Item Name: Replacement Skidtube (Fits LH or RH)

DRAWING NO. D2650	TITLE 206/407 SKIDTUBE ASSEMBLIES	REV. F	DART AEROSPACE LTD ENGINEERING ORDER		D.E.O. NO. D2650-F-1	SHEET NO. SHEET 1 OF 1	SCALE NTS
DRAWN <i>JP</i>	CHECKED <i>A.P.</i>	MFG. APPR. <i>AA</i>	APPROVED <i>HA</i>		DE APPR. <i>HA</i>		
DATE 12.10.12	DATE 12.10.22	DATE 12.10.22	DATE 12.10.22		DATE 12.10.22

CHANGE C'BORED WELDED CROSSBOLT SPACERS TO SWAGED SPACERS

DETAIL G

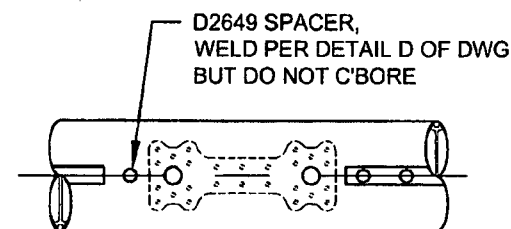
ADD DETAIL G BELOW, WHICH IS THE SAME SECTION VIEW AS DETAIL D OF DWG.

C'BORED HOLES ARE NOW SWAGED PER DETAIL G BELOW. FOR THE Ø0.375 HOLE THAT IS NOT C'BORED, WELD PER DETAIL D OF DWG (SEE AMENDED DETAIL B FOR REFERENCE).
